**GREATER HARTFORD TRANSIT DISTRICT
GHTD IFB #13-018
BROWNSTONE MASONRY REPAIRS TO UNION STATION**

Addendum #1

SGH Project 130525.04

Sheet No.
SPM-01

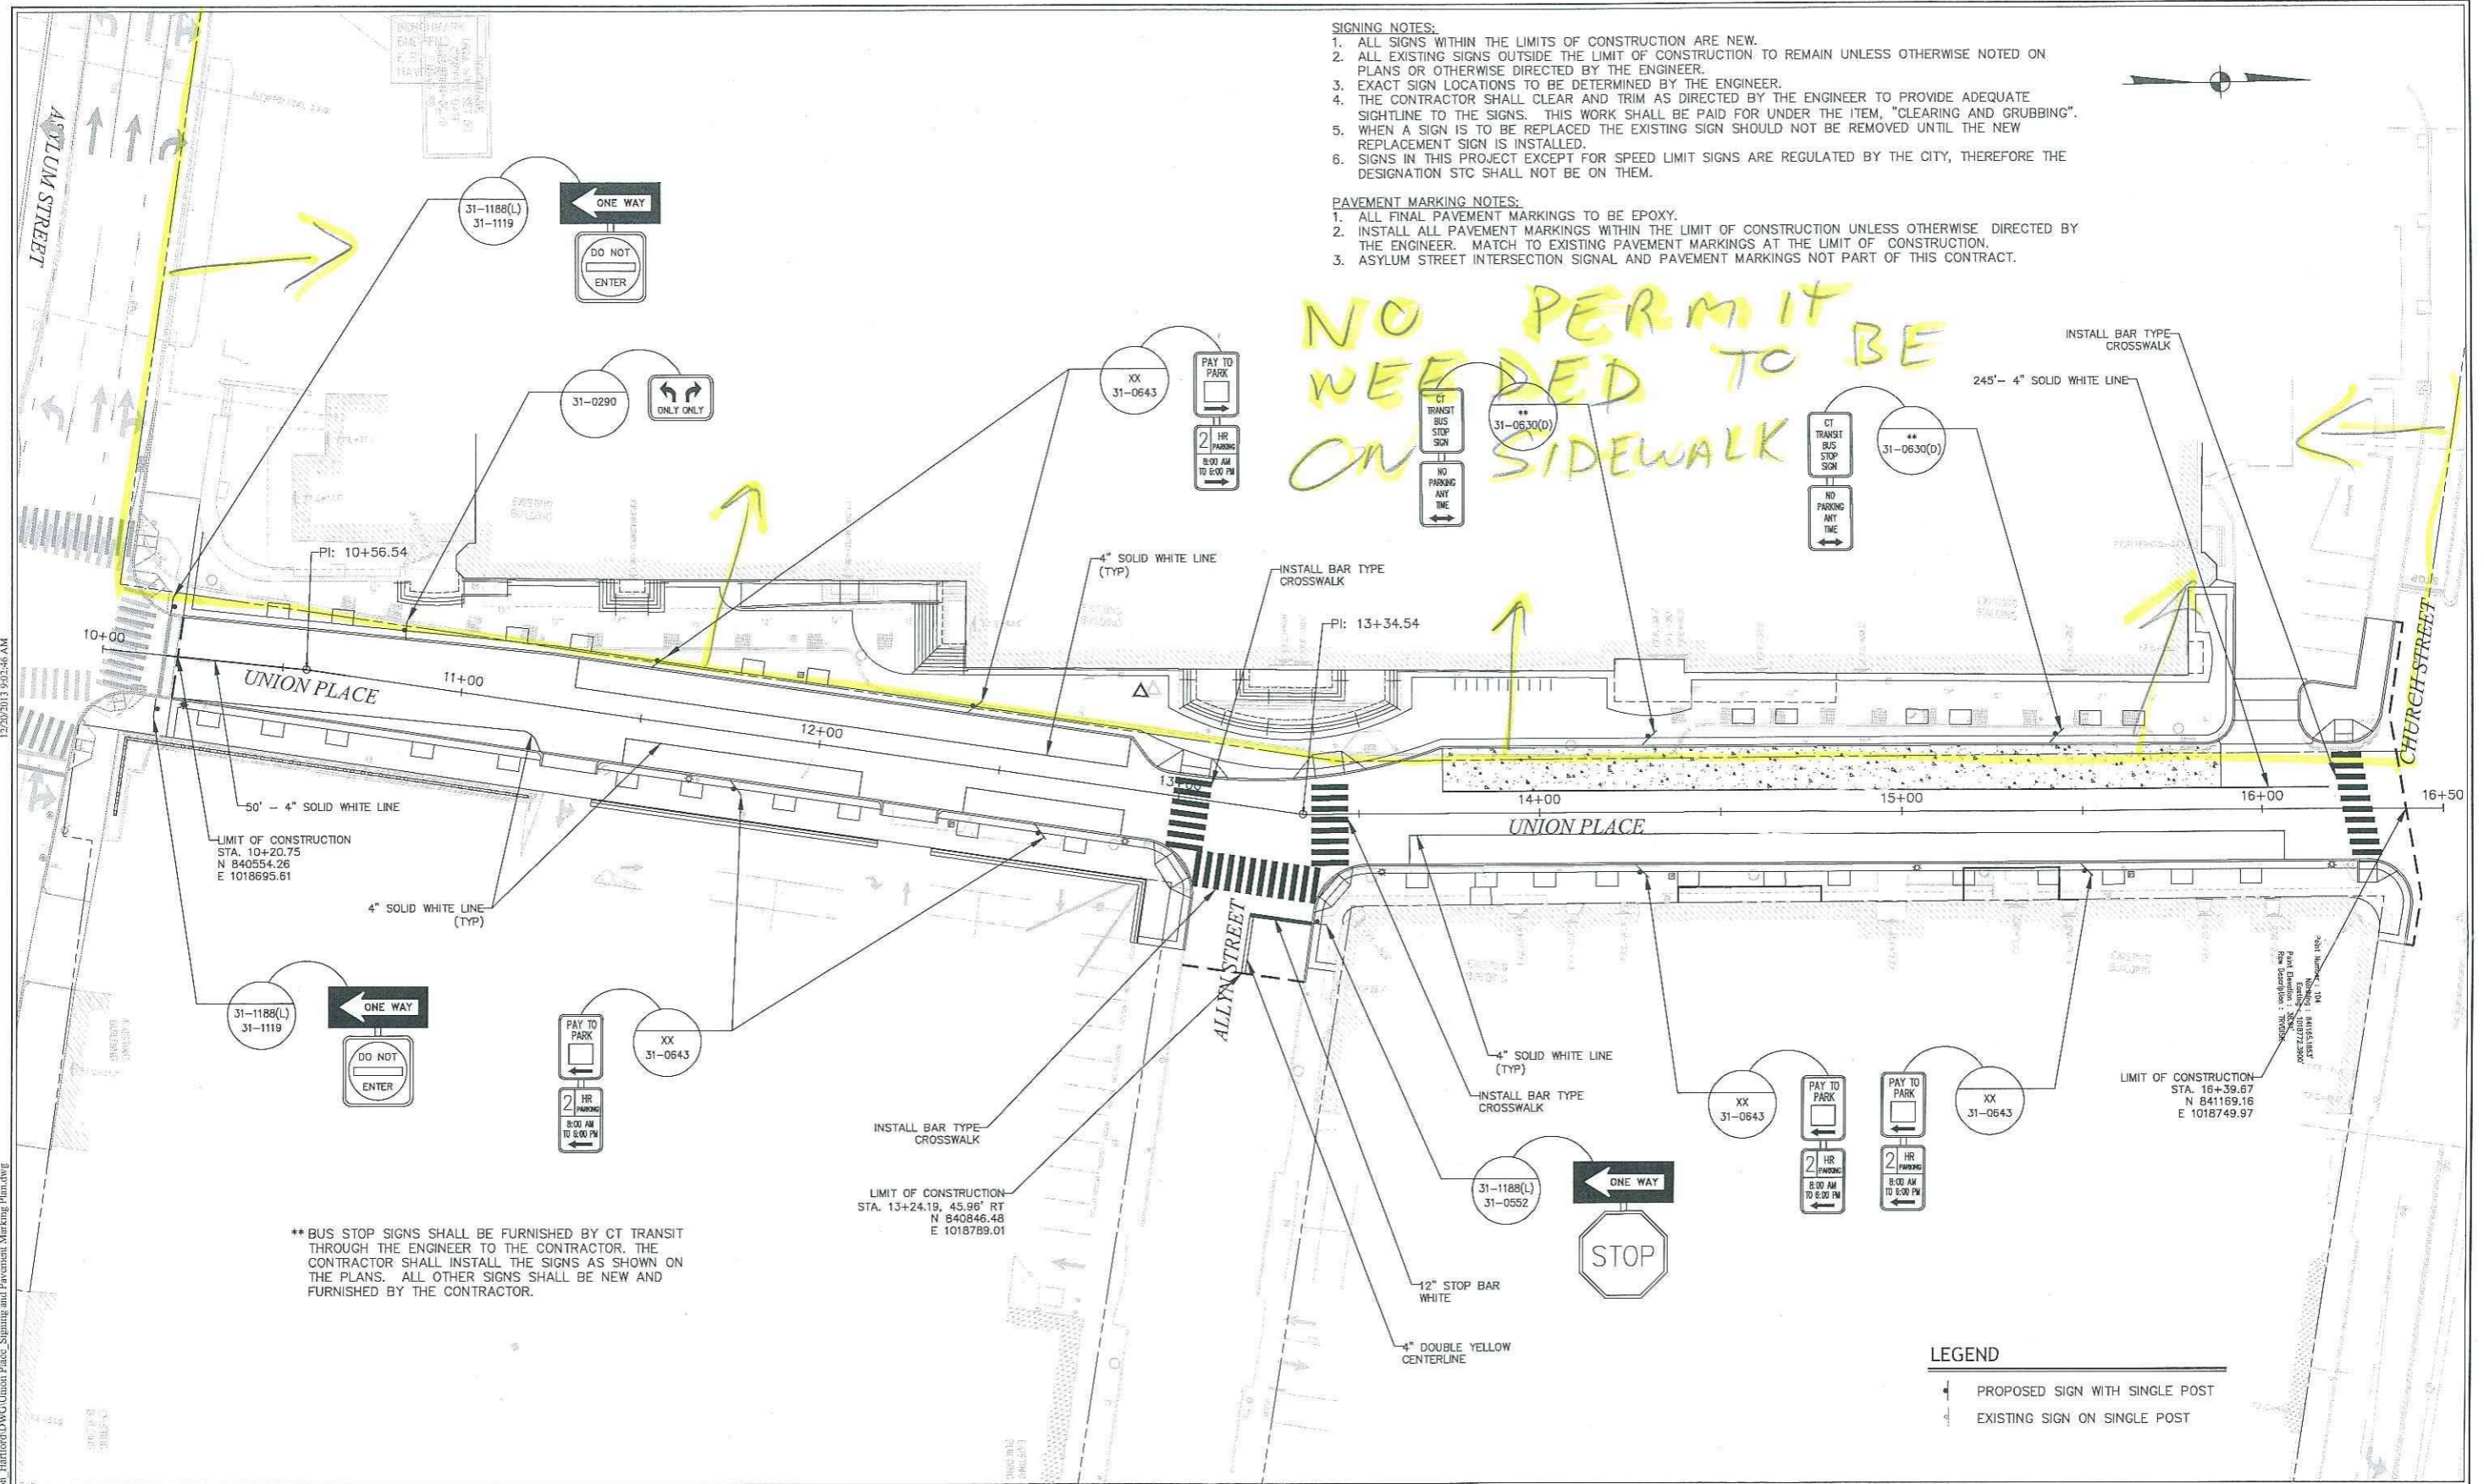
1. **INQUIRY:** How much of the sidewalk can the contractor take up? Does the contractor need to apply for a permit for the sidewalk?

RESPONSE: The contractor must maintain a 4 ft minimum width of the sidewalk for public access. As long as the work does not block portions of the city's right-of-way and the work stays between the building and the property line, an obstruction permit is not required. Attached is a plan sheet with the property lines highlighted. If the work will extend into areas outside of the property lines, then the contractor will need to obtain an obstruction permit from DPW.

NO PERMIT NEEDED TO BE ON SIDEWALK
